## HISTORIC AND DESIGN REVIEW COMMISSION

**HDRC CASE NO:** 2023-447  
**ADDRESS:** 318 W ROSEWOOD AVE  
**LEGAL DESCRIPTION:** NCB 6460 BLK 11 LOT 30, 31 & W 1 FT OF 29  
**ZONING:** R-5, H  
**CITY COUNCIL DIST.:** 1  
**DISTRICT:** Monte Vista Historic District  
**APPLICANT:** Otto Arango/ARANGO OTTO M  
**OWNER:** Otto Arango/ARANGO OTTO M  
**TYPE OF WORK:** Retaining wall installation  
**APPLICATION RECEIVED:** November 08, 2023  
**60-DAY REVIEW:** January 7, 2023  
**CASE MANAGER:** Claudia Espinosa

The applicant is requesting a Certificate of Appropriateness for approval to add a retaining wall to the front yard.

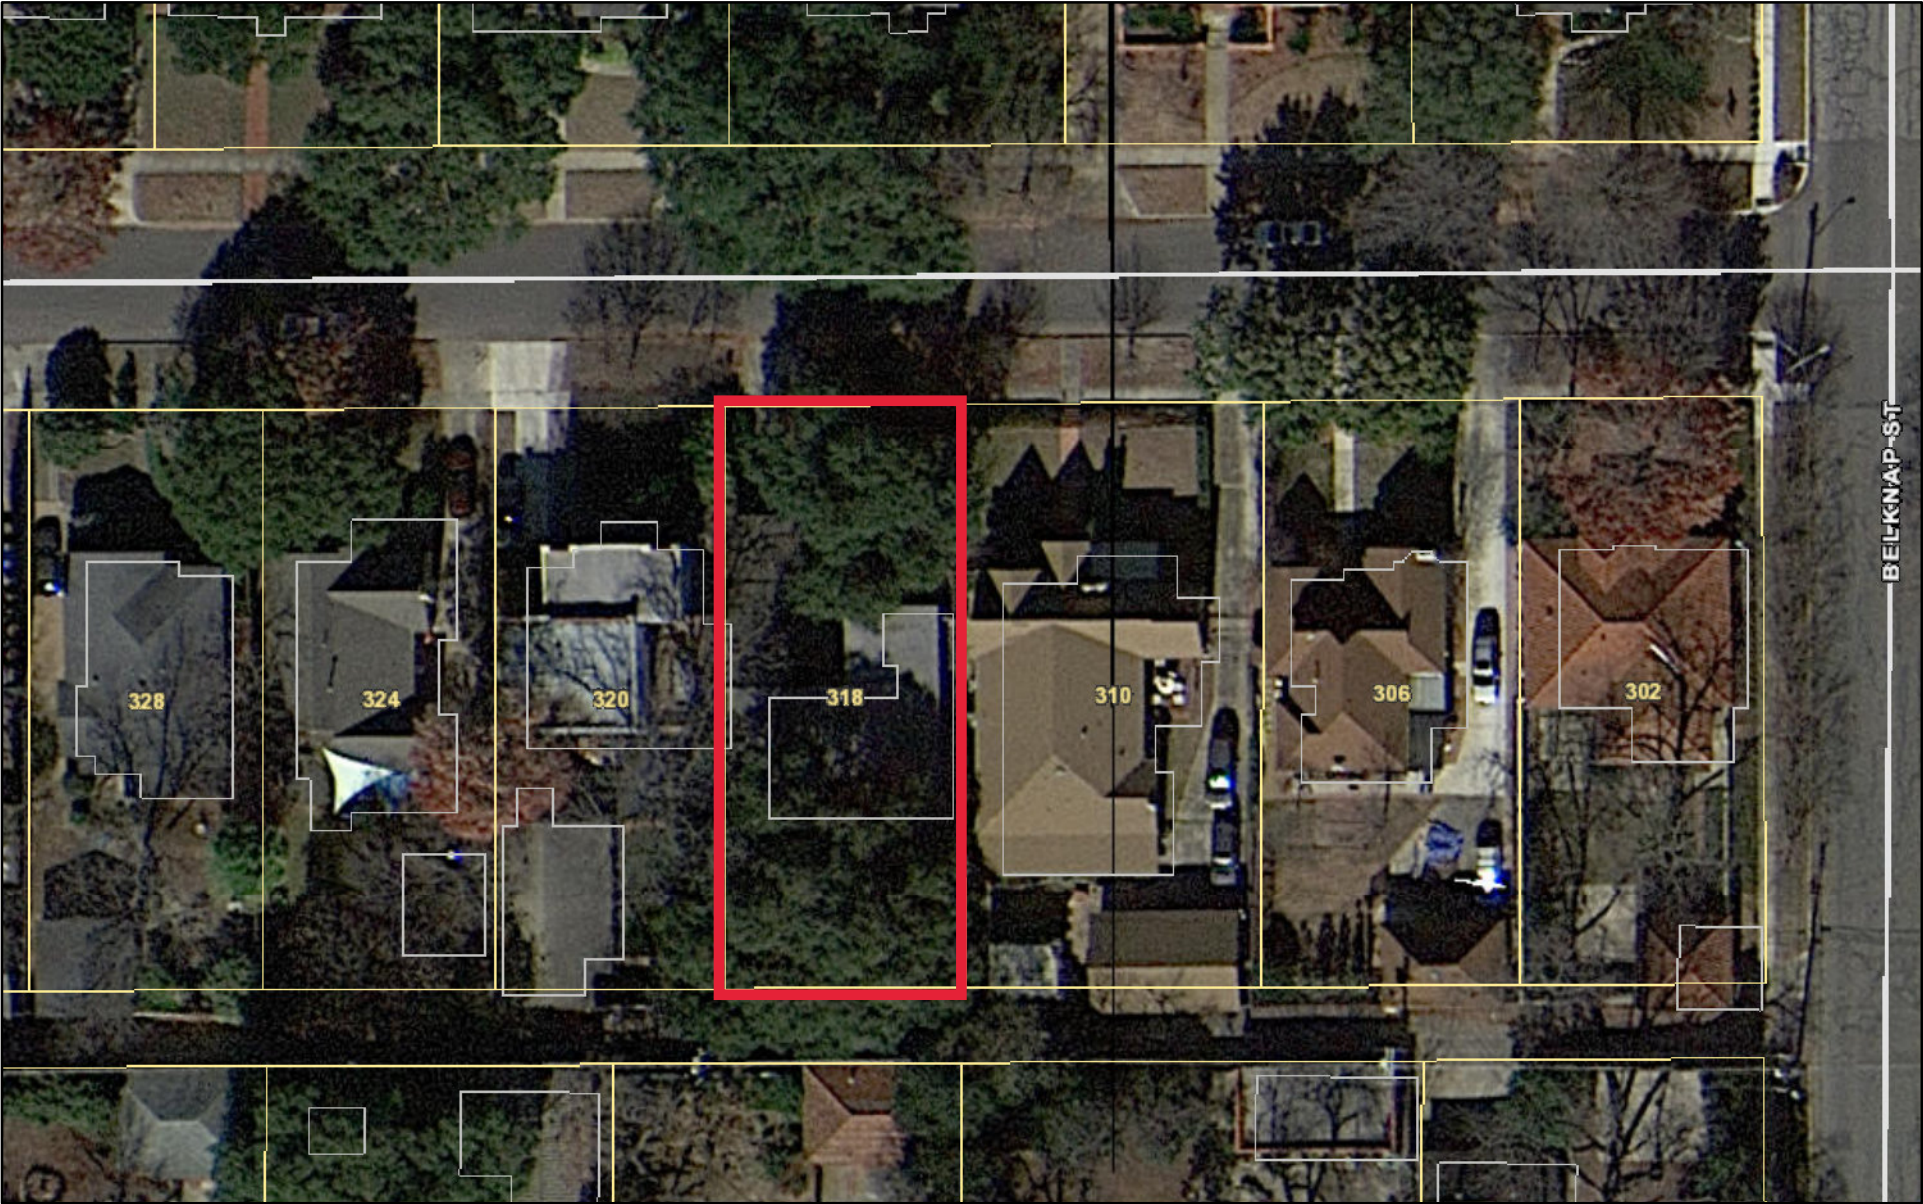
b. **RETAINING WALL** – The applicant has proposed to construct a new retaining wall in a dry stack stone pattern from the sidewalk up to the landing of the front walkway. The design is intended to match the existing stone wall on the property located at the driveway. The Guidelines for Site Elements 1.A.i note to avoid significantly altering the topography of a property (i.e., extensive grading). Do not alter character-defining features such as berms or sloped front lawns that help define the character of the public right-of-way. There is at least one other property on this block that features a staggered stone retaining wall. The proposed wall will also follow the shape and slope of the existing berm. Staff finds that the proposed retaining wall installation to be consistent with the Guidelines.

Staff recommends approval of the retaining wall installation based on findings a through b with the following stipulations:

- i. That the applicant construct the retaining wall in a dry stack stone pattern to match existing.
- ii. That the applicant construct the retaining wall in a height that does not extend beyond grade or property line.
